October 19, 2008

You have asked that I evaluate the language of the Regional Water Quality Control Board's proposed performance standard that recommends "Effectively attenuate significant increases in storm runoff. Runoff from vineyards shall not cause or contribute to downstream increases in rates of bank or bed erosion." (Table 4.1). Specifically, you ask about the Staff Report's interpretation of that mandate specifying limits on peak stormflow runoff of 10-15%.

## Napa TMDL Suggested 10-15% Peak Flow Runoff Limitation Robert R. Curry October 19, 2008

Figure 1. Mainstem Napa River peak flow frequency plot for Log-Pearson Type III analysis restricted to 1982-2004 water years.

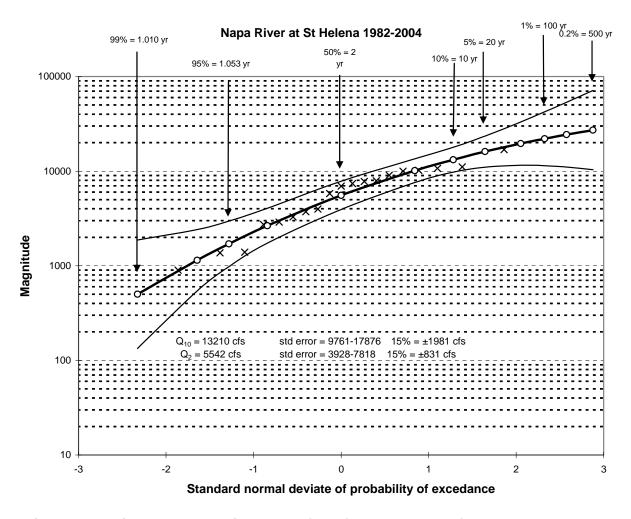
I have considered what 15% change may mean to the mainstem Napa River. To look at this in perspective, we may consider what 15% of current (not-preproject) conditions may mean to the Napa River at St Helena. The attached graphic is a plot of flood magnitudes versus frequency for that site for the water- years 1982 to 2004. By focusing on this relatively recent peak flood flow record rather than the 60+ years of total record, we more realistically consider the cumulative effects of dams and urbanization from the 1980's to the present. Most hydrologists would agree that the proposed 15% hillside vineyard runoff constraints will most likely be locally effective for the smaller, more-frequent, storms in the vineyards themselves. However, the effects of long-duration (several-day) cumulative rainfall events that may have a recurrence magnitude of 50-100 years are much less predictable with the current models.

Looking only at 2-year (average annual) and 10-year return-period instantaneous peak runoff values for the Napa River at St. Helena, we calculate the following:

Two Year Return Flow: 5542 cfs; 15% is ±831 cfs; Standard Error of estimate 3928 cfs to 7818 cfs Ten Year Return Flow 13210 cfs, 15% is ±1981 cfs; Stnd Error - 9761-17876 cfs

What this means is that a total 15% increase in peak flood-flow magnitude for 2-10 year magnitude events would be lost in the statistical noise by the time you looked at the mainstem Napa River.

Looking at the downstream receiving waters in the Napa River, we would have a difficult time proving that a cumulative 15% increase in peak flow values had occurred, based on the current stream gauging network. The Standard Error of the Log-Pearson extreme-value estimates is insufficiently precise to detect a 15% change. Even if we assumed a statistically normal distribution with a smaller standard deviation, net changes may not be detected. This is just the way that rivers and their complex alluvial flood plains work when storms of differing magnitudes, different durations, and different antecedent conditions result in runoff.
